ATTACHMENT 1

SUMMARY OF PROPOSED CHANGES

PROPOSED CHANGES

Specification DF 6.3 - Site, Design Features

FIGURE 6.3-2

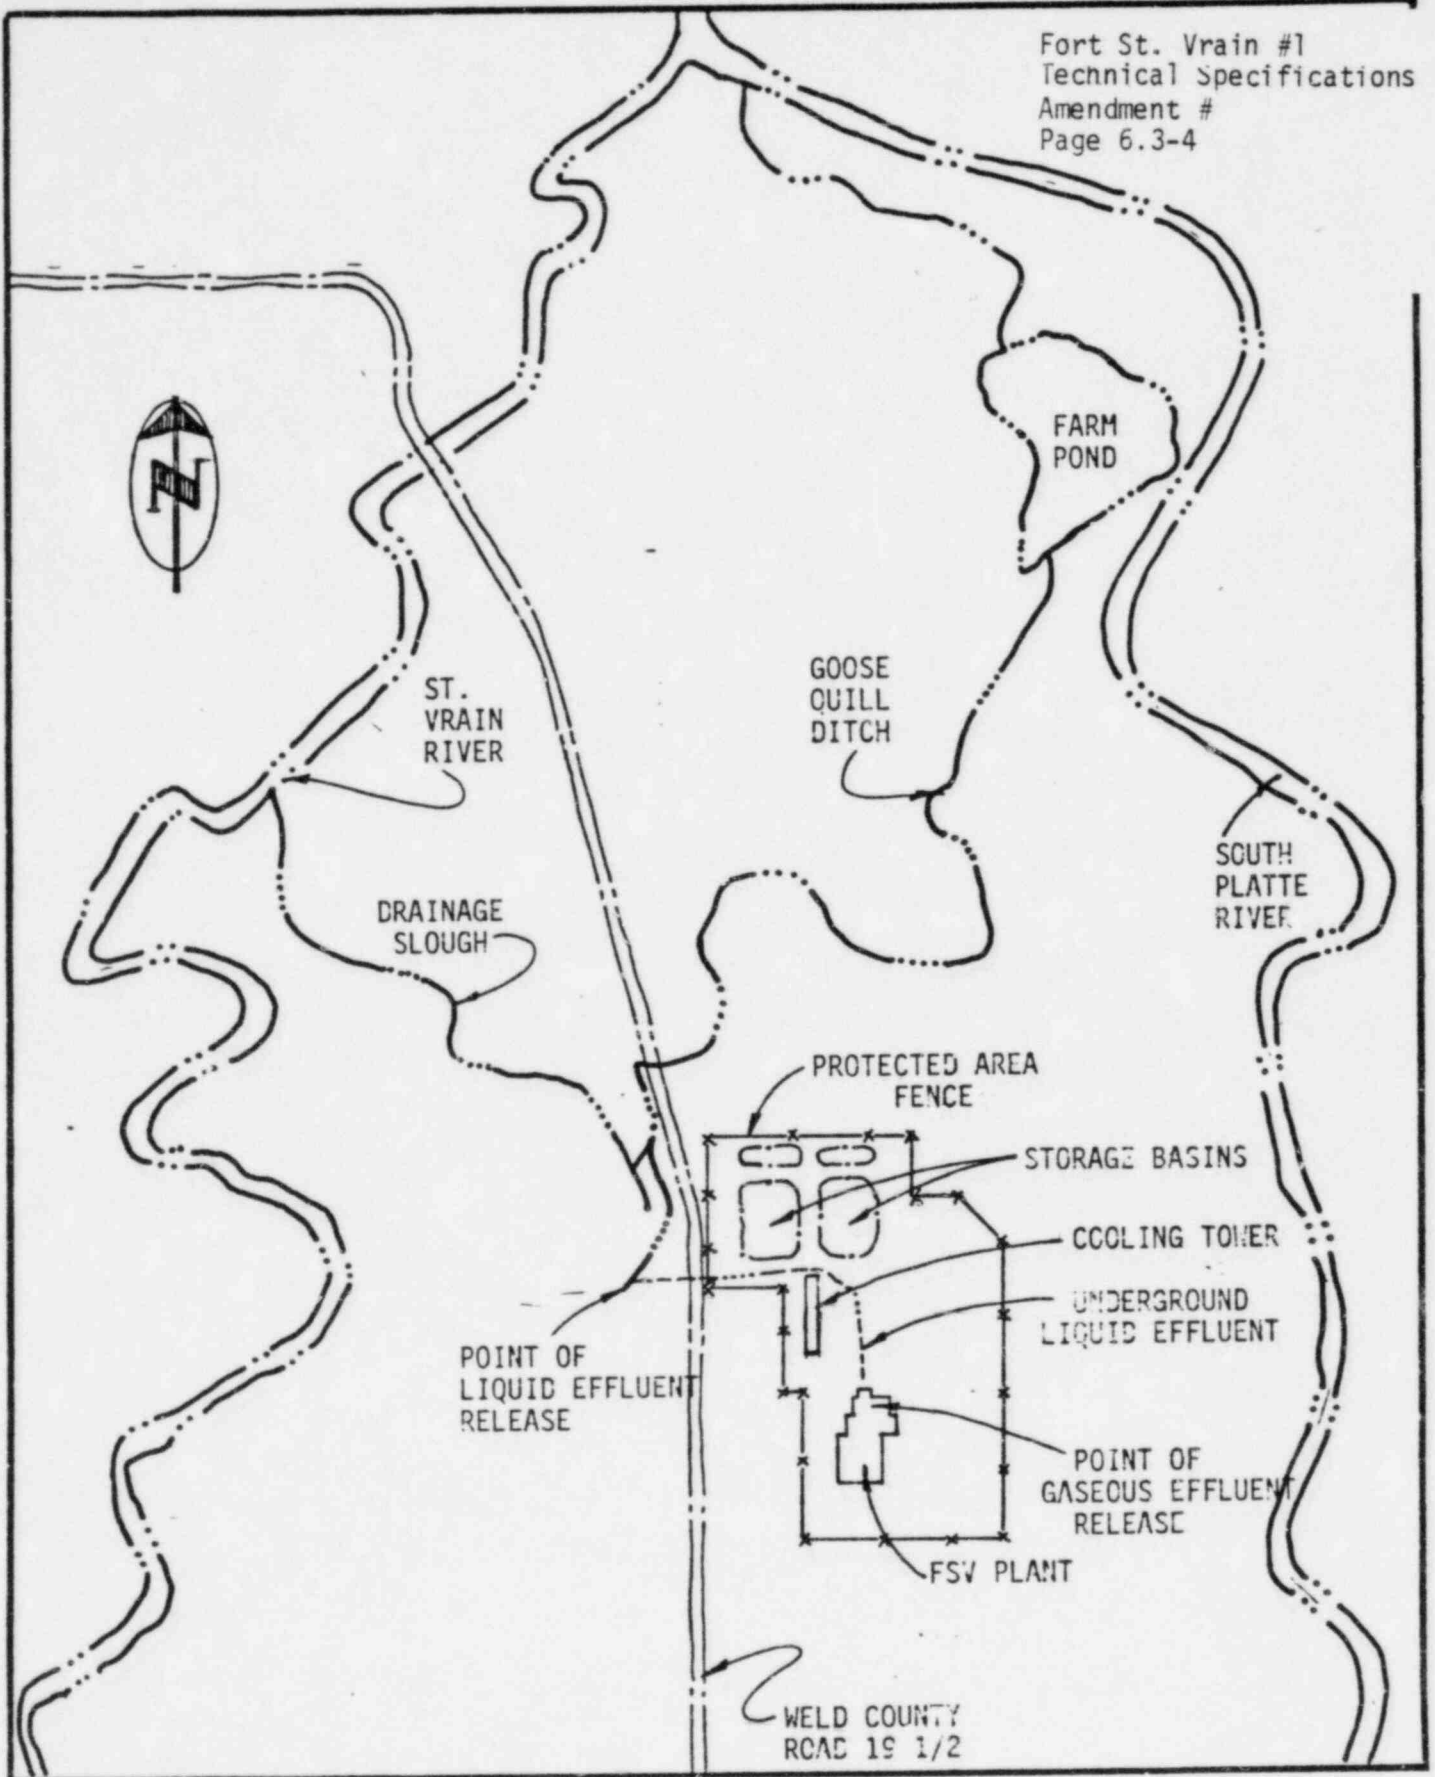
<u>Section</u>	<u>Description of Change</u>
4.8	Deleted, replaced by new Section 8.0.
5.8	Deleted, replaced by new Section 8.0.
6.3	Provided additional information regarding radioactive effluent pathways and general site layout.

| Points where radioactive gaseous and liquid effluents are
| released are shown on Figure 6.3-2 as are the liquid
| effluent pathways leaving the site.
